**DECOMMISSIONING PLAN
FOR
ROCKWELL INTERNATIONAL HOT LABORATORY
LICENSED UNDER
SPECIAL NUCLEAR MATERIAL LICENSE
SNM-21**

September 28, 1990

The April 15, 1990 revision of the Decommissioning Plan for Rockwell International Hot Laboratory was submitted to the Nuclear Regulatory Commission (NRC) for approval in April 1990. The NRC reviewed the plan and, in a letter dated July 3, 1990, identified 12 areas where additional information was needed before final approval could be given.

Figure 2-1. Layout of RIHL Facility

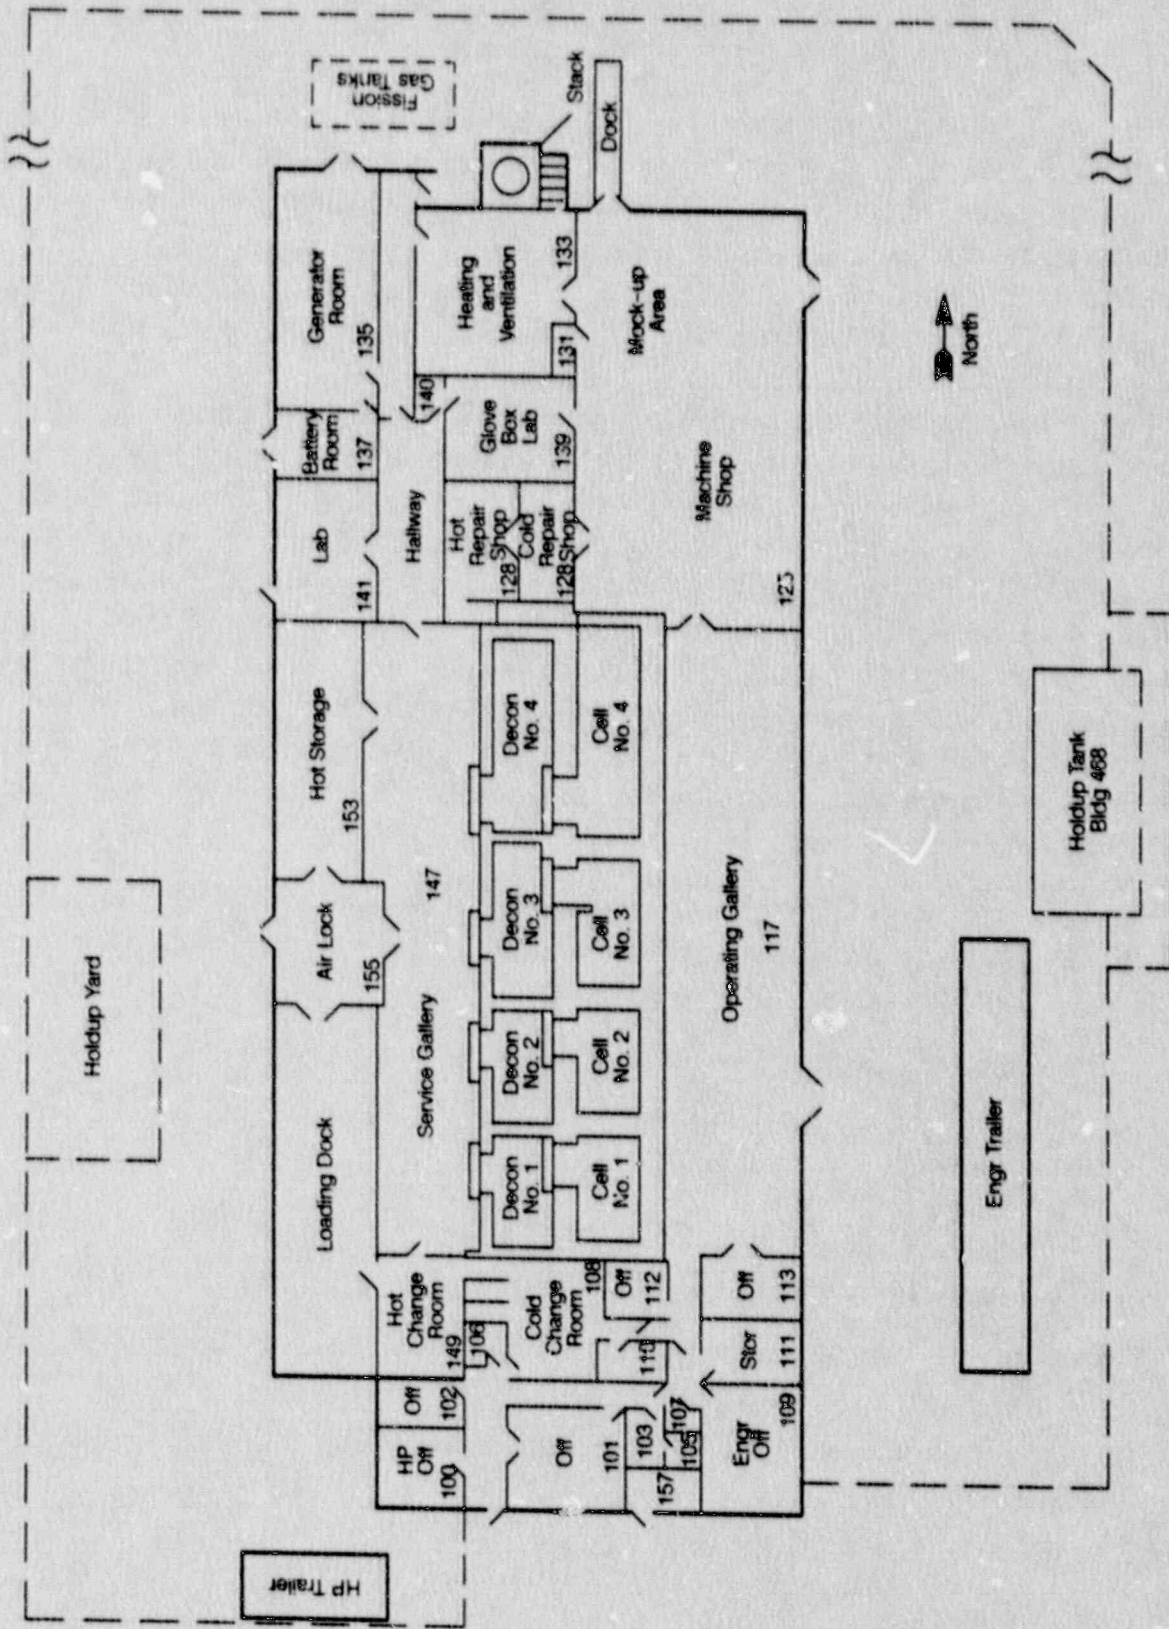
Provide a more detailed description of the proposed decommissioning activities that will be performed in the various areas. Include all areas.

Section 2.2, "Decommissioning Description," has been rewritten to provide additional detail. The list of areas in the RIHL which will require decontamination was rearranged to be consistent with the schedule and the written description. Figure 2-1 was modified to show north and the location of Rooms 103 and 157.
